On behalf of RVA YIMBY, we are writing in support of Ordinance 2023-346 authorizing the special use of the properties at 901 North 36th Street and 909 North 36th Street in the 7th District for up to 10 single family homes.

Project Response: Ord. No. 2023-346

Address: 901-909 N. 36th St.

PROPOSES LAYOUT #901 - #911 N. 36TH STREET

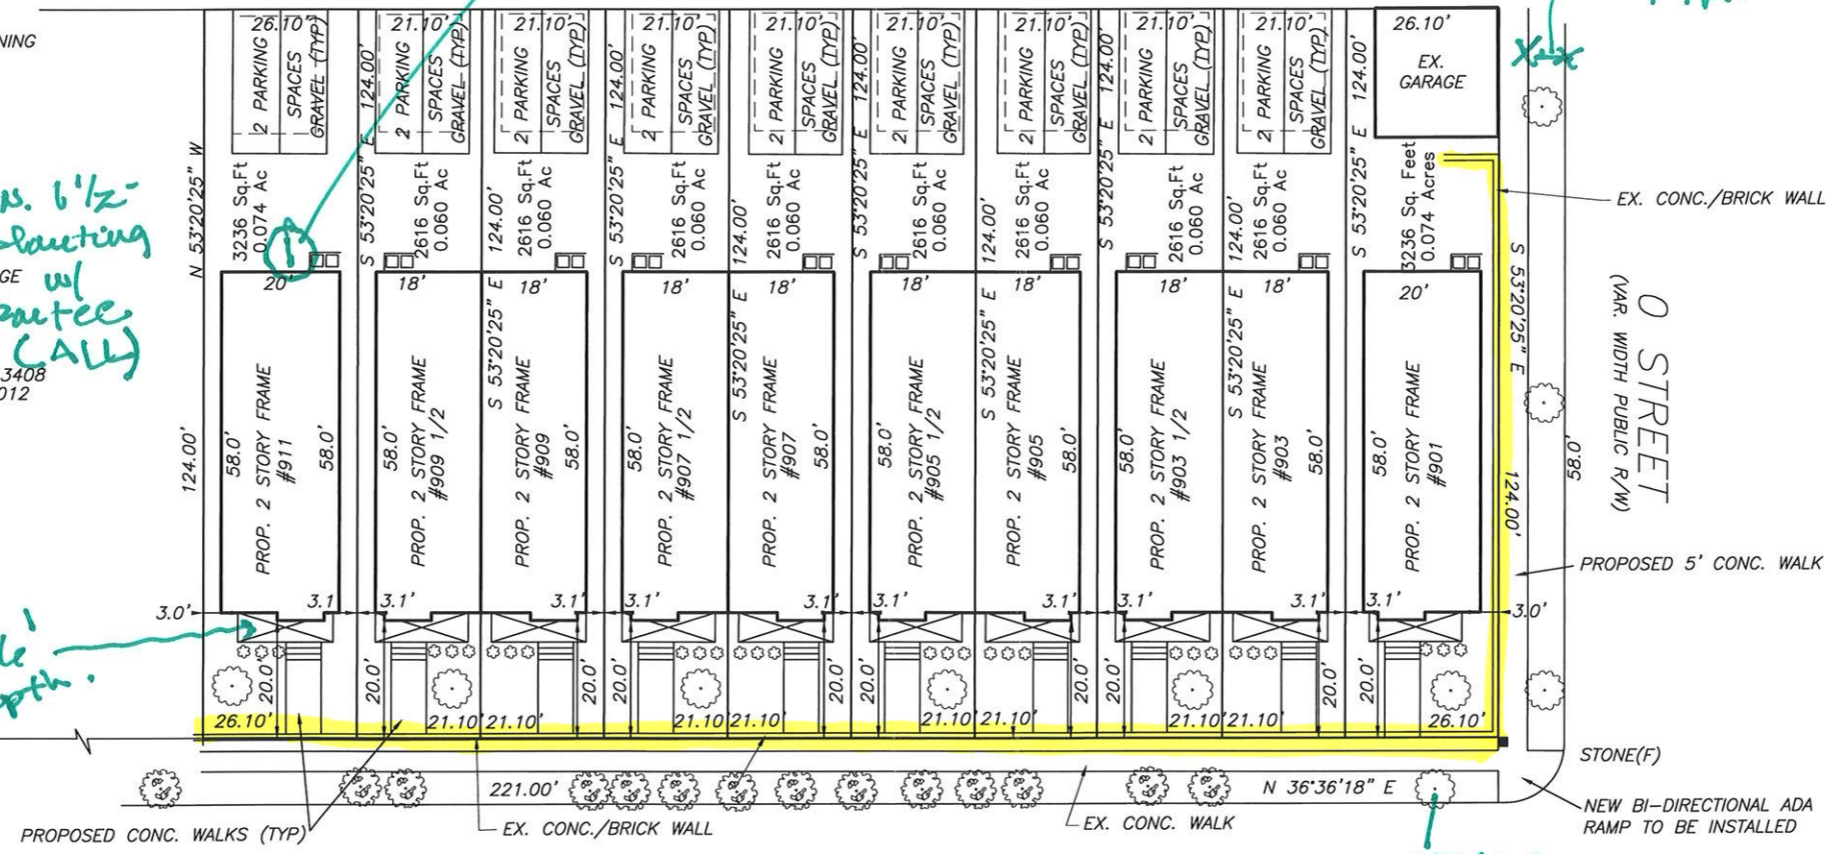
- Site plan does not conform to building plans. Please adjust

so that they align (rear stoops, what happens to existing garage on O St., walks, etc.)

- e. Need more detail on what's going to happen with retaining wall and how this will connect with walk to respective units.

① show REAR stoop ON SITE PLANS. (ALL UNITS)

Dimension tree lawn

Trees min. 6 1/2" calipers planting w/ guarantee (ALL)

6' depth

CONCRETE WALL DAMAGED & POWING SEVERAL LOCATIONS. TELL HOW THEY'RE GOING TO BE FIXED TO NOT PUSH COSTS ONTO RWG OWNERS

SHEET:
A1.2

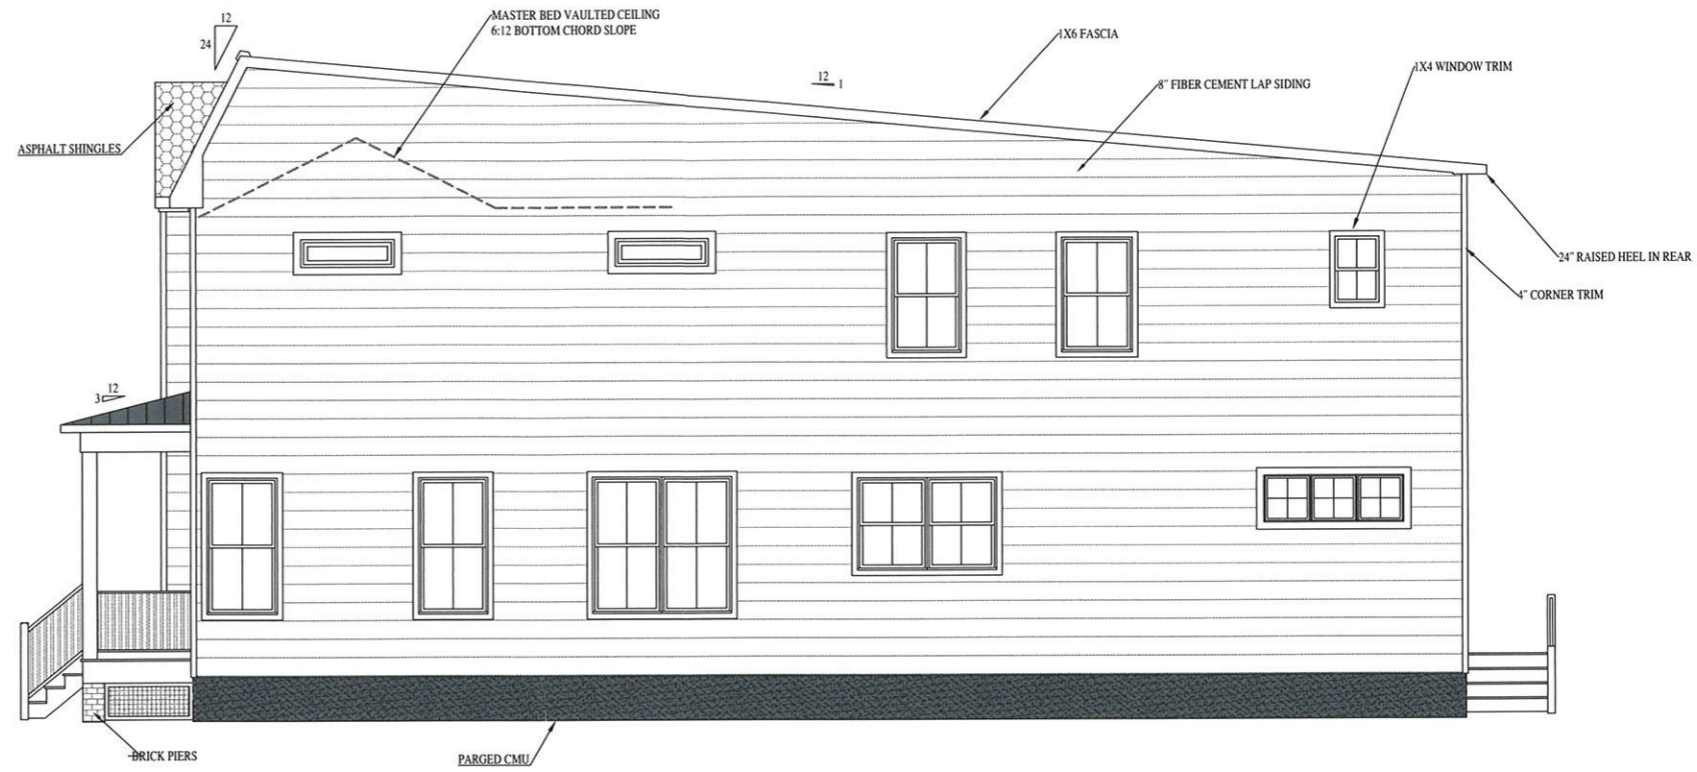
WHITE OR BLACK VINYL WINDOWS TO MATCH ON ALL SIDES → Good!

HEIGHT OF 1ST FLR. WINDOWS, B.T.W. # PORCH DECK CAN ILLUS. WHO RAILING SHOW THIS WOULD BE OK, TOO!

21 FOUNDATION HEIGHT. SHOW ON PLANS.

SHEET:
A2.1

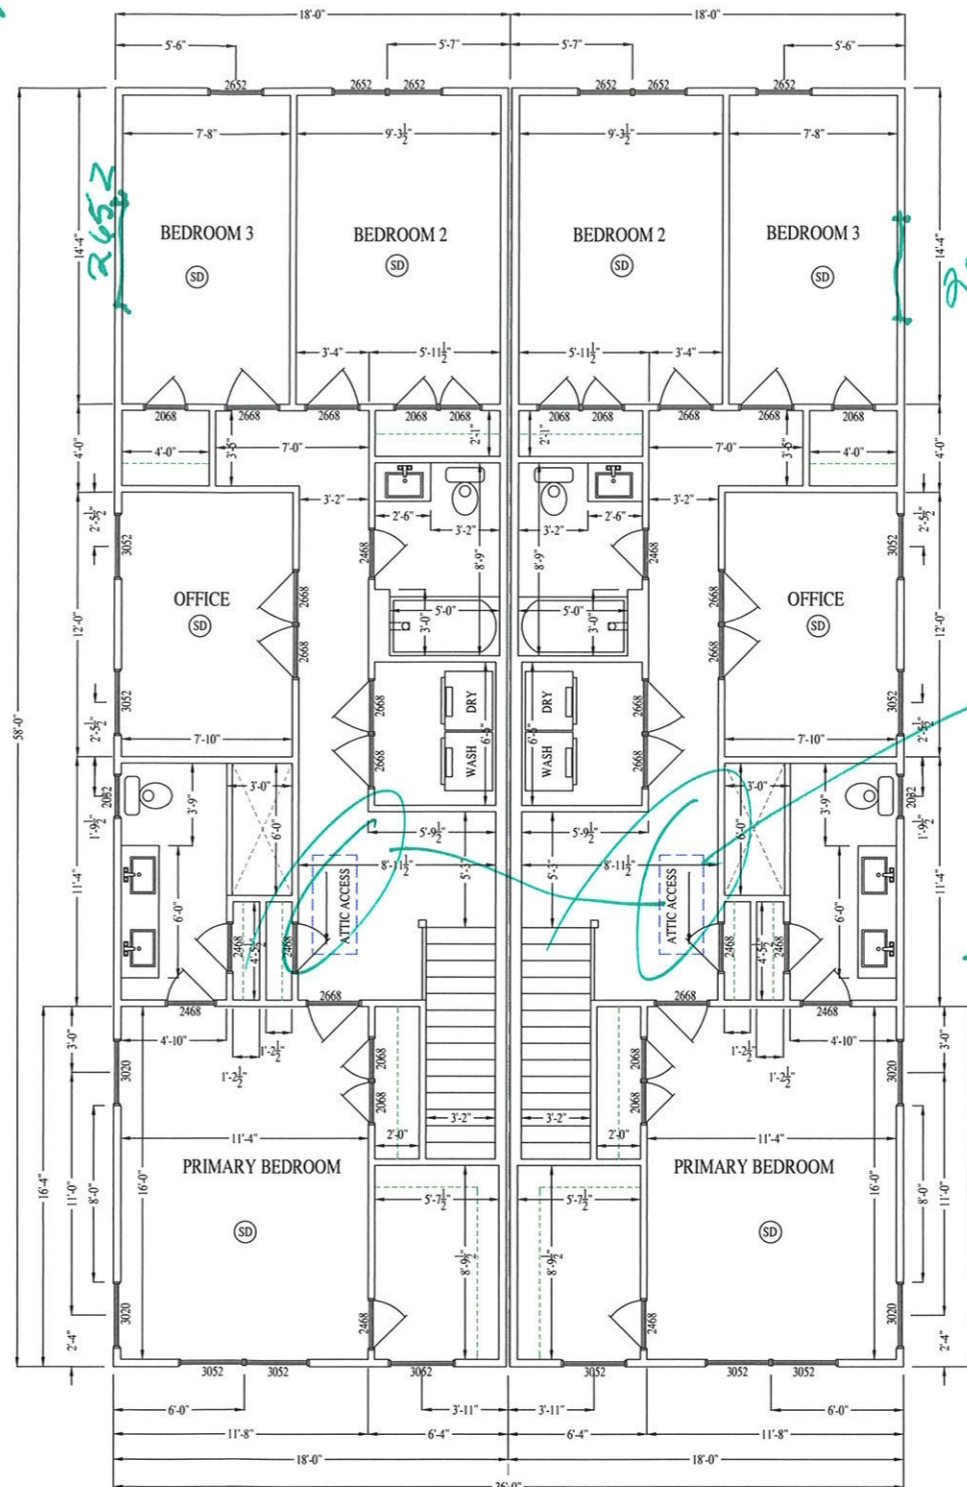
pls. see notes sheet A-1

W/ndr 3060

why not sup. down attic recess. these units need storage! accessible

SHEET:
 A2.2

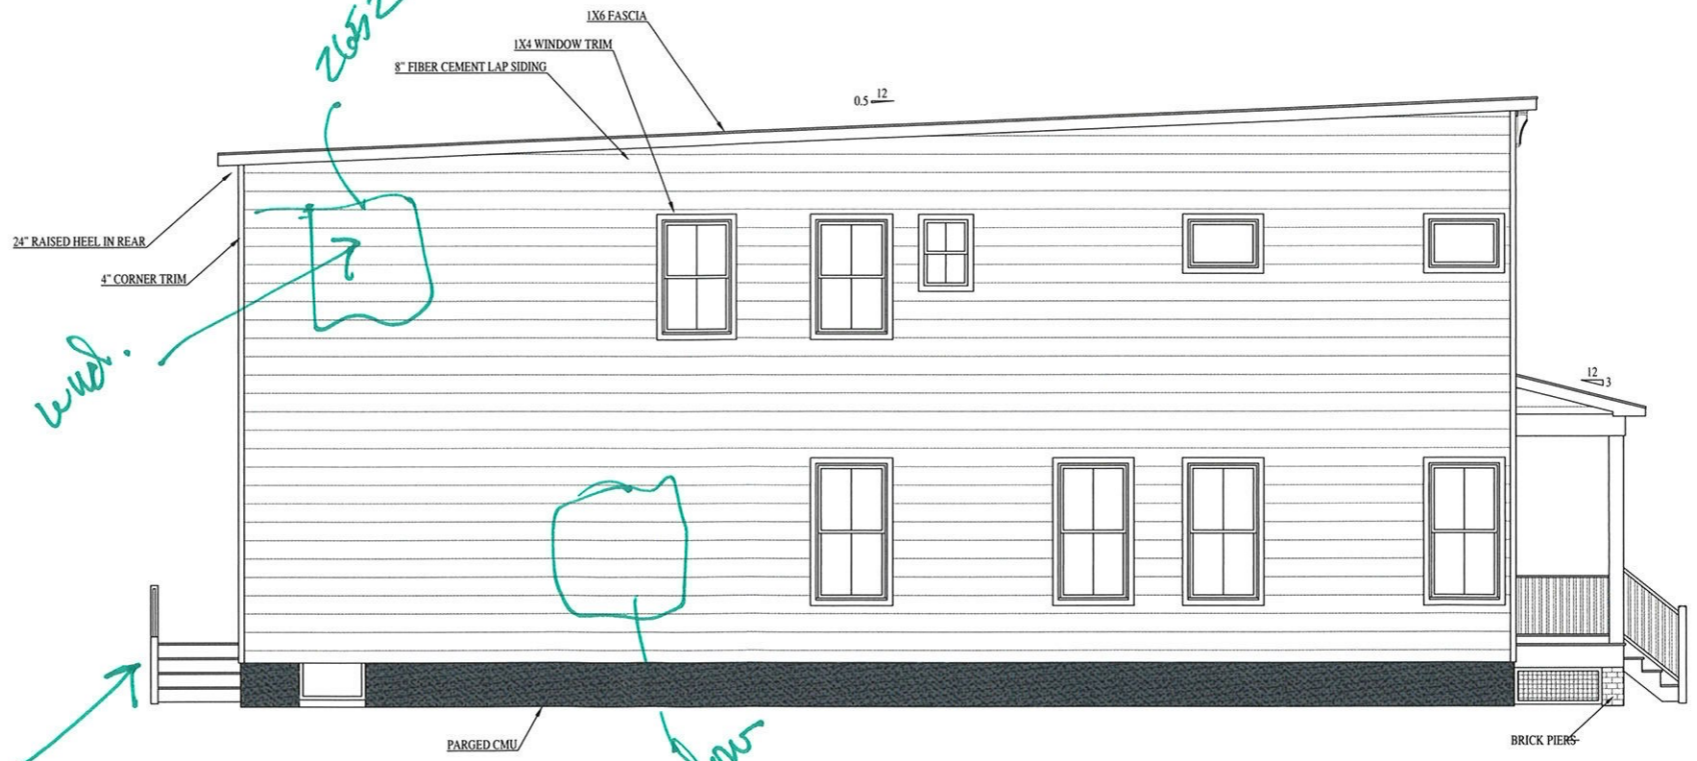
PLS SEE NOTE A1.1

see note on SHT A1,2

wnd.

windows 30x60

SHEET:
A2.3

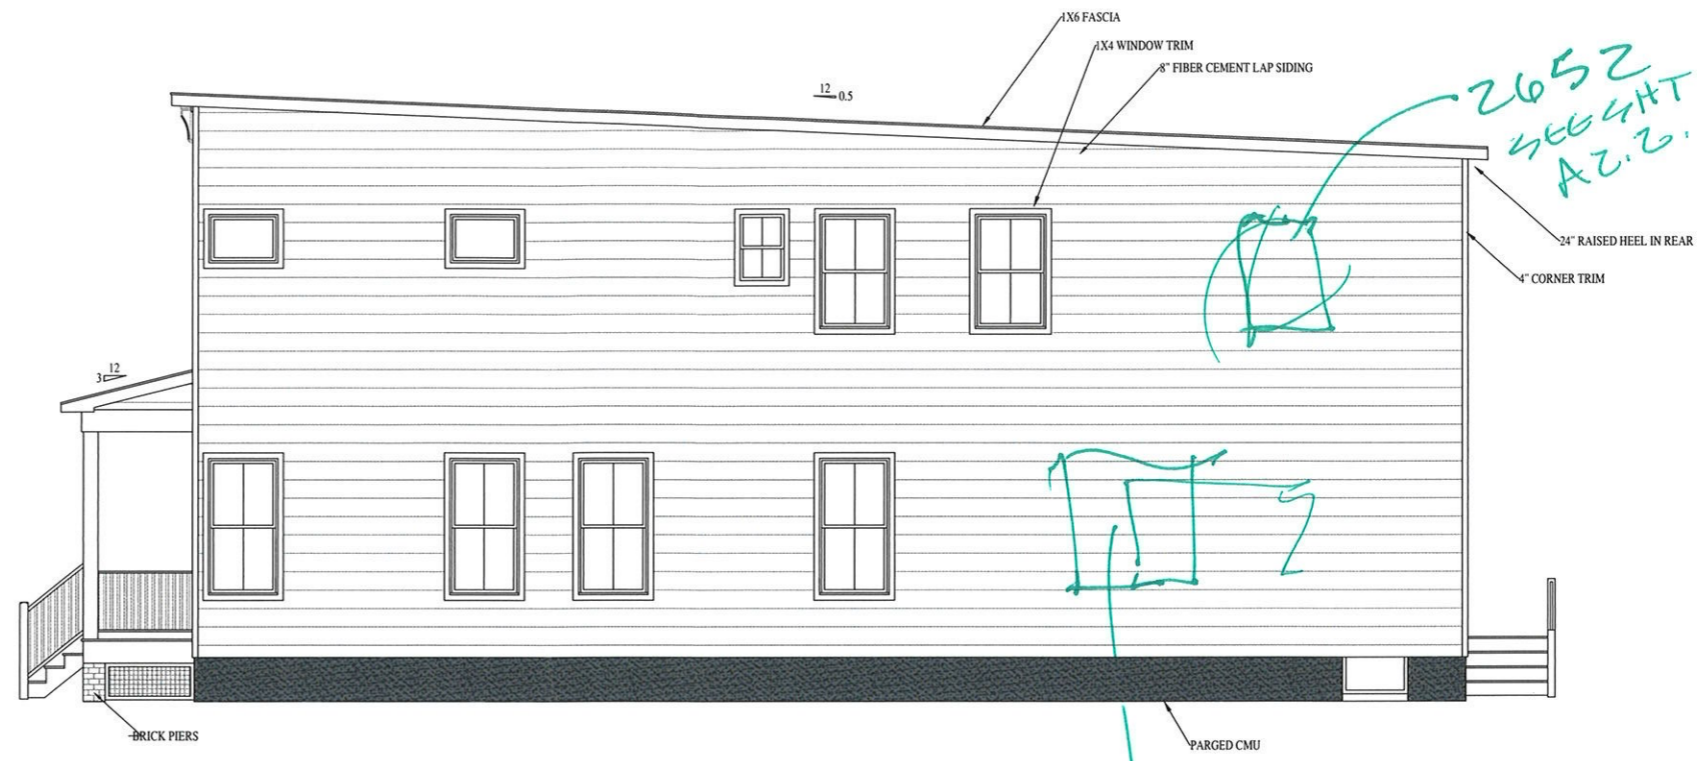
*2652
SEE SH1
A2.2.*

*3060
SEE SH1
A2.2*

SHEET:
 A4.2

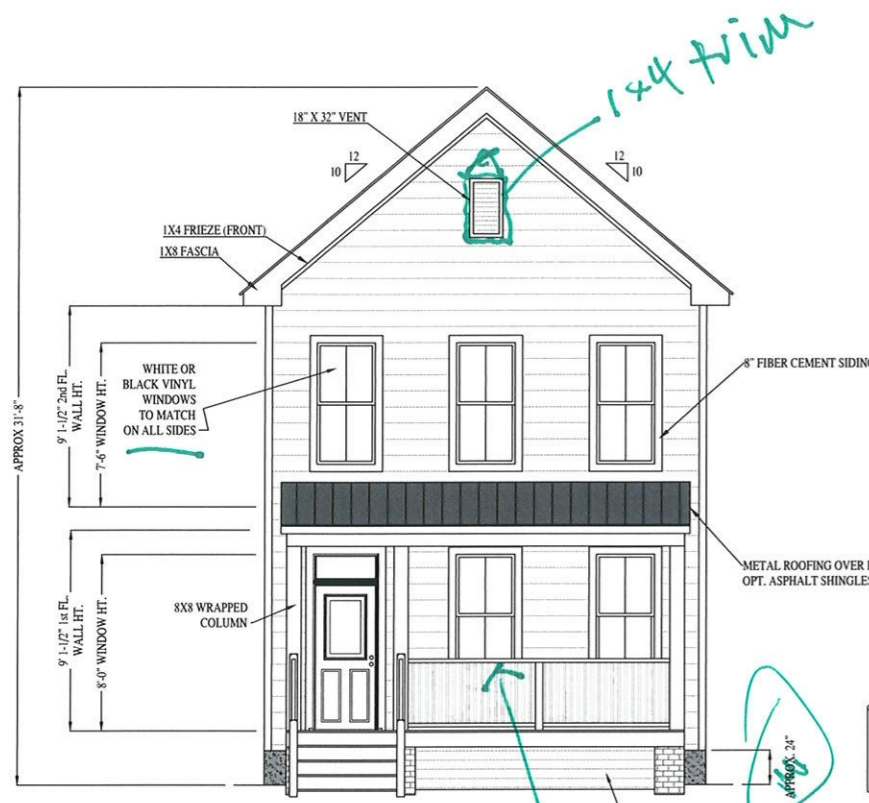
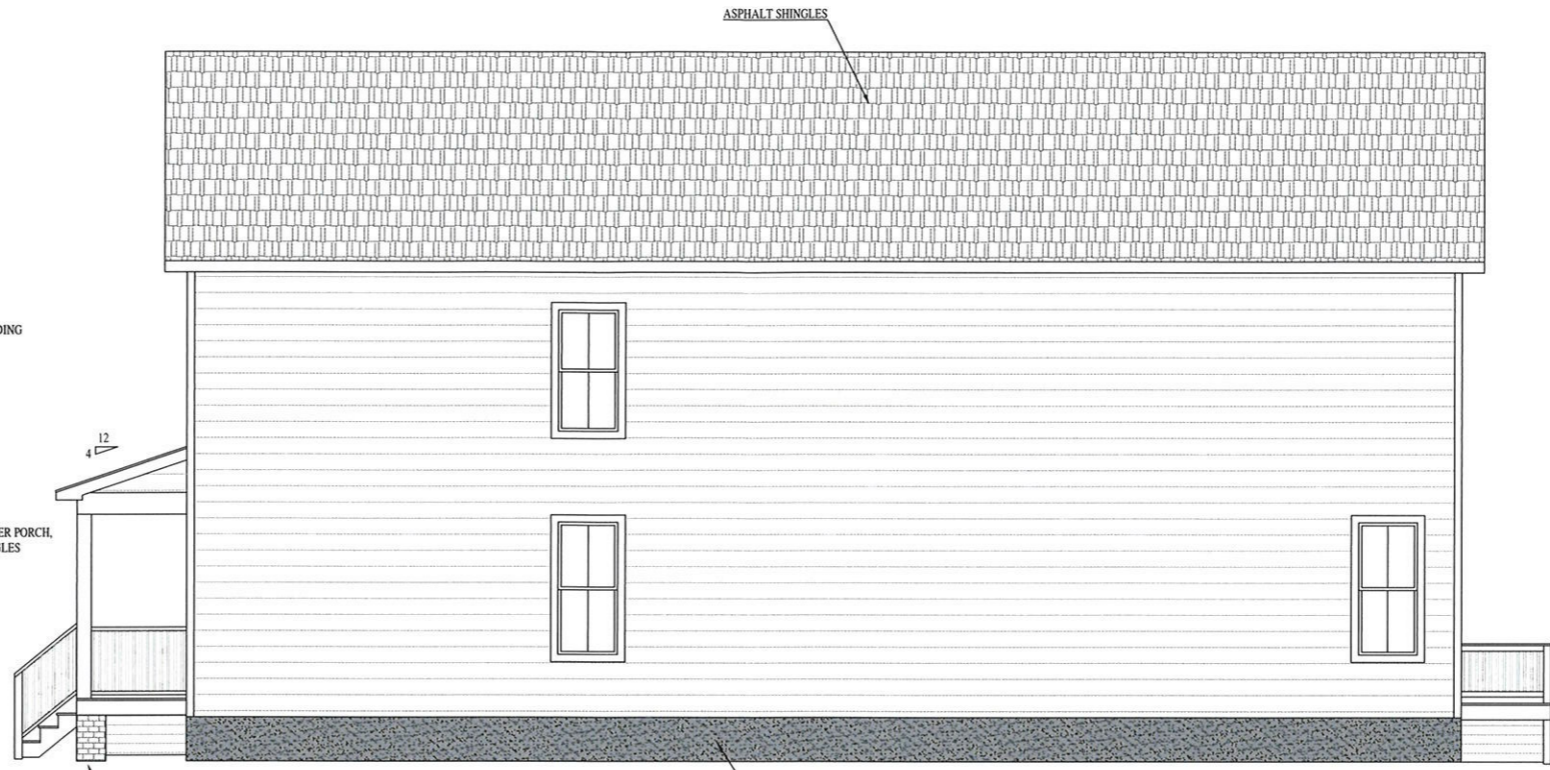
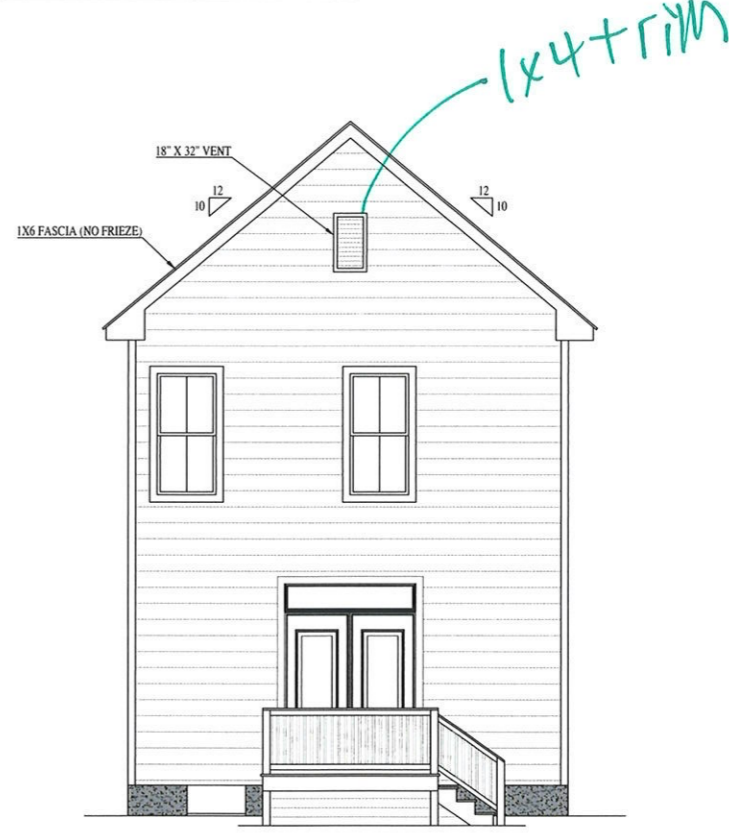
NOTE 9th Fl. 2

1x4 + trim

SHEET:
A5.1

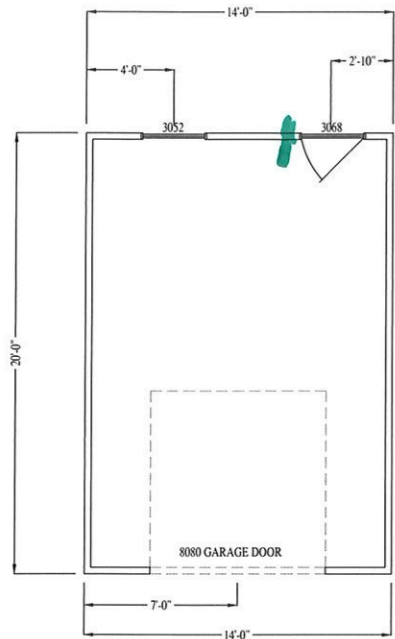
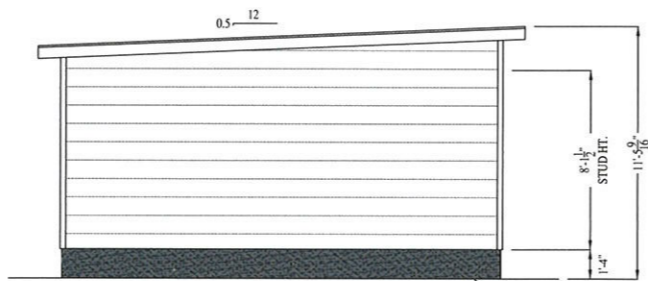
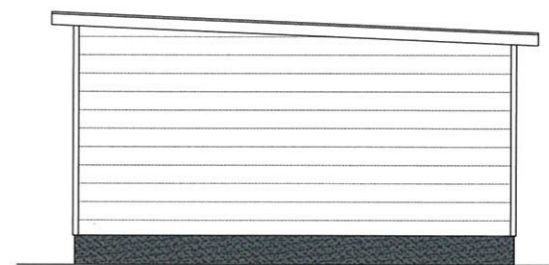
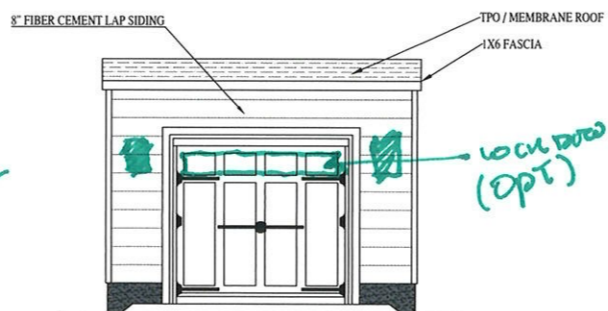
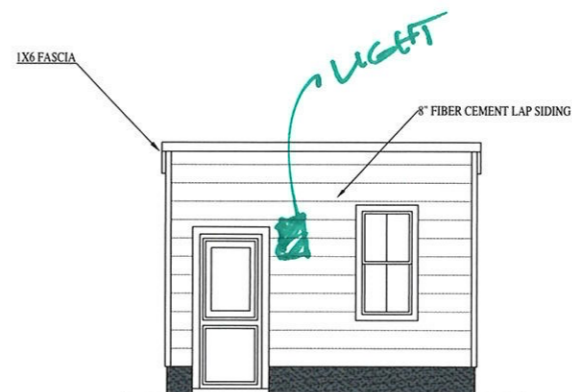
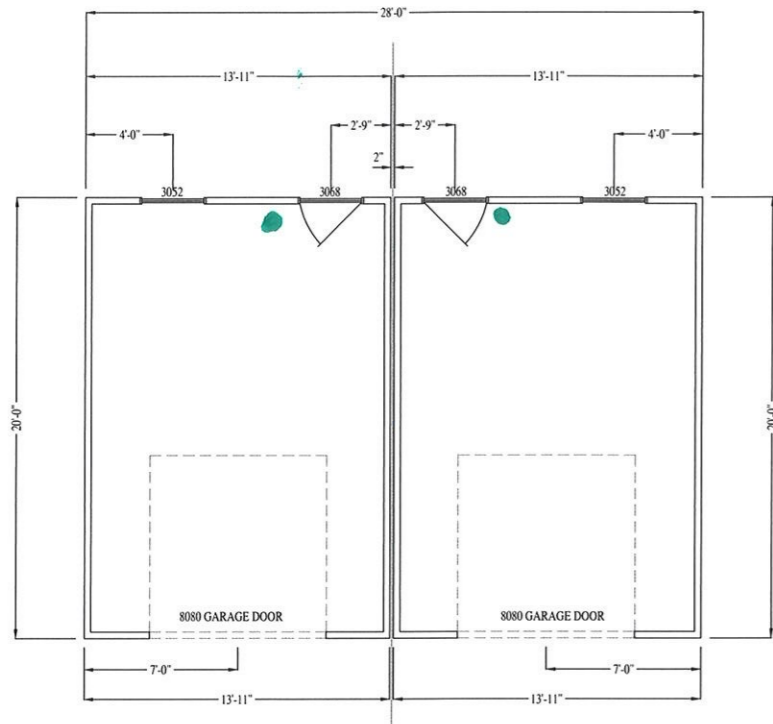
PLEASE
ADD APPROX
VEH. DIMENSIONS
(IS THIS 1 1/2
OR 2 GARAGE?)

IS ~~THE~~ GARAGE
FOR 901 being demolished?
Site plan shows it
remaining - pls. clarify.

* PROVIDE ROOM
"STUFF" FOR
10 GARAGES FOR
